# Building Code of Australia 2022 Report

Report for BCA Compliance – Rev H

PROJECT NAME: The Maltings Mittagong (Building M3+M4)  
PROJECT NUMBER: GDL190311  
DATE: 27/02/2024

**Figure 3 - Lifts and stairs share the same shaft**

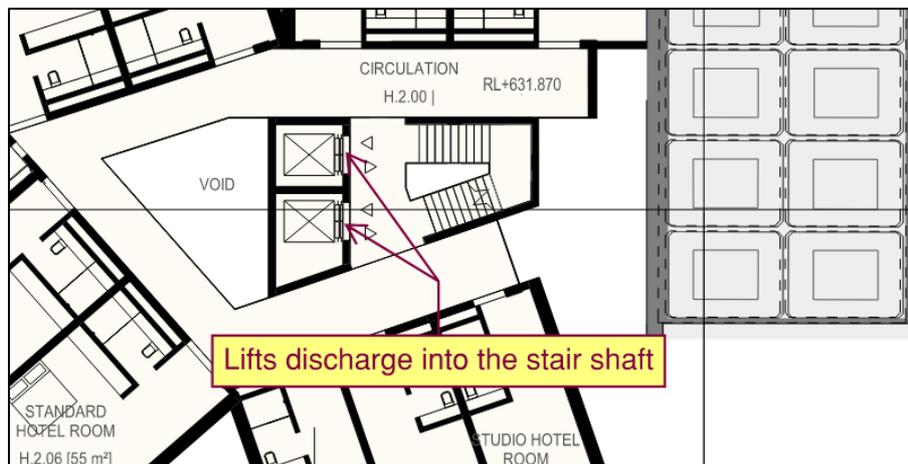
A stairway and lift must not be within the same shaft if either the stairway or the lift is required to be in a fire-resisting shaft.

*Comment: Refer to C3D11 above.*

Figure 5 - Single exit from the carpark

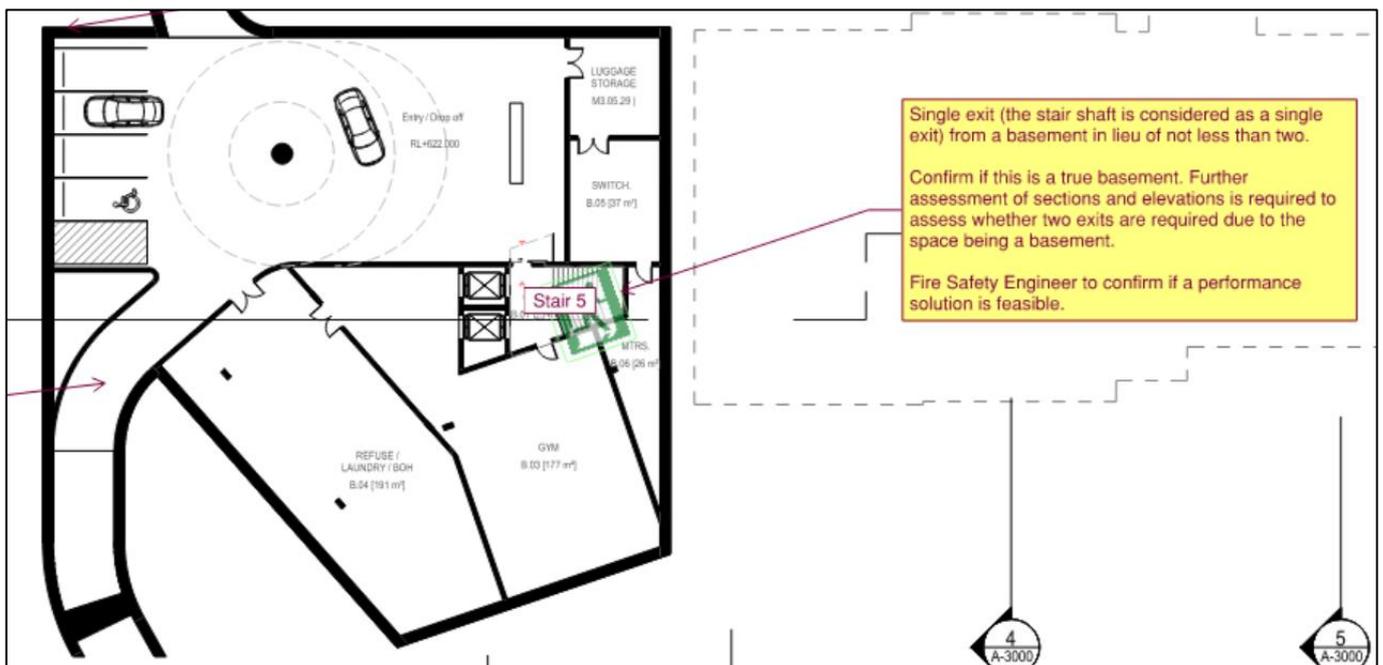
*Comment: In the case of the Class 9b portions in this building, a storey which accommodates more than 50 persons will require a minimum of two (2) exits.*

*Only one exit from the basement has been provided in lieu of not less than two (2). It has been assumed that two (2) exits are required due to the vertical egress rise to the level of discharge is more than 1.5 m, and the floor area of the basement is greater than 50m<sup>2</sup>. It is suggested that Architectural Sections & Elevations be provided for further assessment. The Fire Safety Engineer has confirmed the feasibility of a justifiable performance solution for inclusion in the FER. Refer to Credwell DA Fire Engineer Letter dated 20/02/2024.*

Figure 6 - fire separation required between the stair shafts

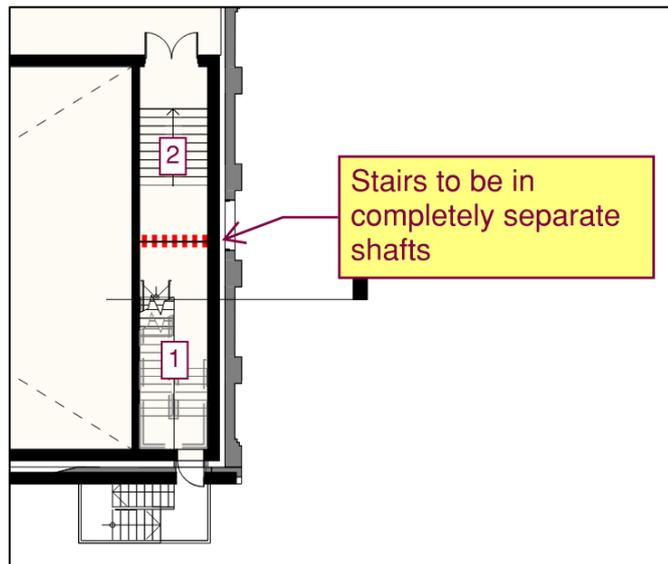
Note the following comments apply to the stairs designated as '1' and '2' below:

- a) Stair 2 is considered to be a non-fire-isolated stairway as it passes through three (3) storeys.
- b) Stair 1 is considered to be a fire-isolated stairway as it passes by four (4) storeys. To achieve this, there needs to be fire separation between each shaft. Where compliance cannot be achieved, the Fire Safety Engineer would need to review and comment on the feasibility of a justifiable performance solution.

**Figure 7 - Discharge of non-fire-isolated stairs**

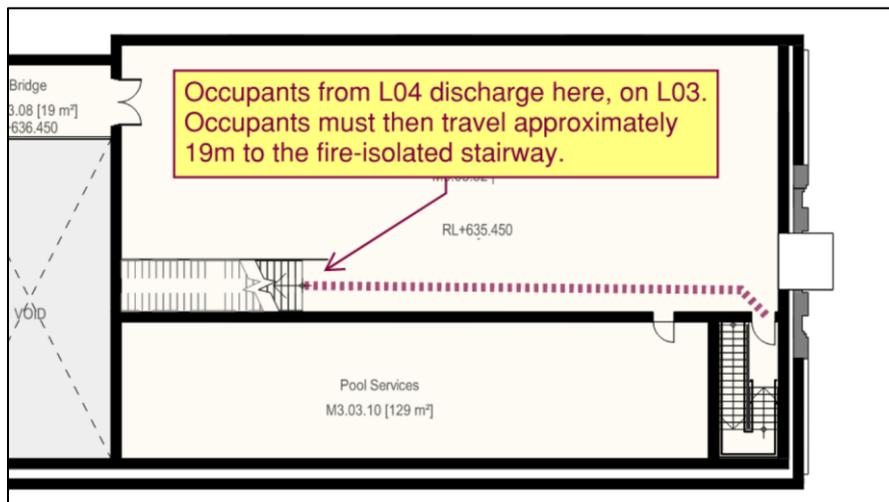
*Comment: The required non-fire isolated exit stair (stair 7) discharges on Level 3 in lieu of within 20 m of an external exit door on Ground Level. The Fire Safety Engineer has confirmed the feasibility of a justifiable performance solution for inclusion in the FER. Refer to Credwell DA Fire Engineer Letter dated 20/02/2024.*

# M3/4 Plan L03 - L04

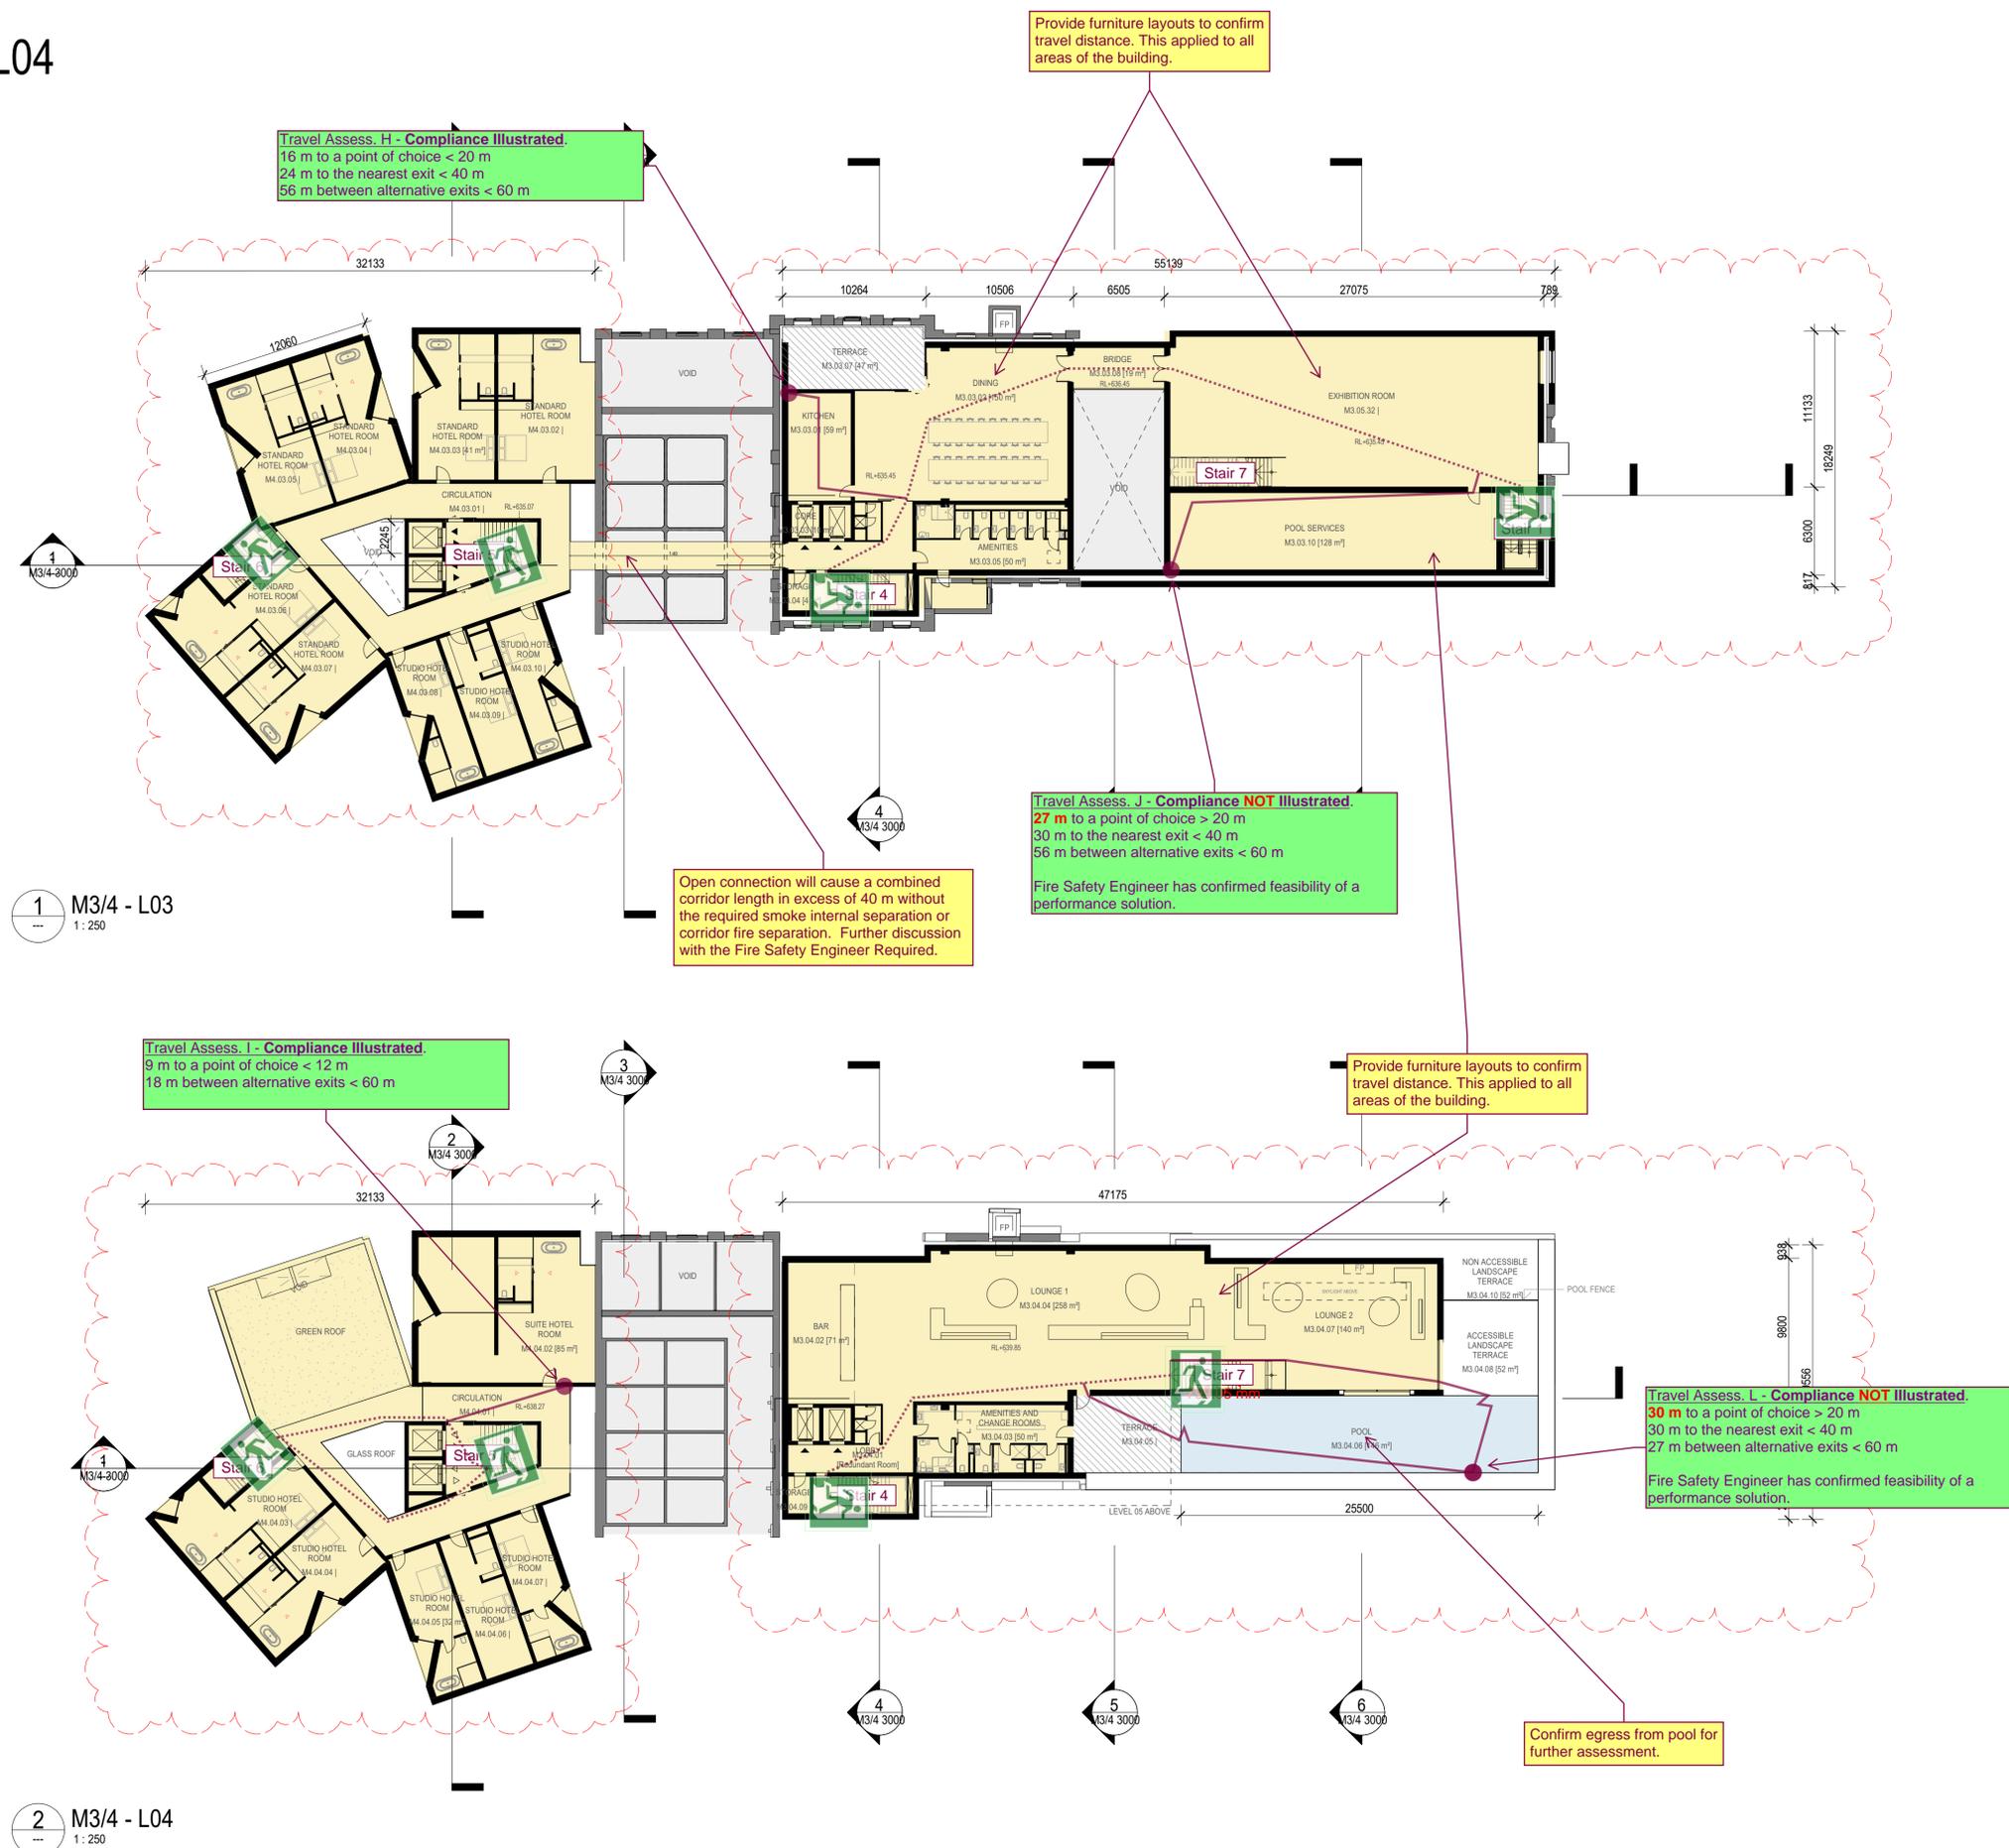
**Travel Assess. H - Compliance Illustrated.**  
 16 m to a point of choice < 20 m  
 24 m to the nearest exit < 40 m  
 56 m between alternative exits < 60 m

Provide furniture layouts to confirm travel distance. This applied to all areas of the building.
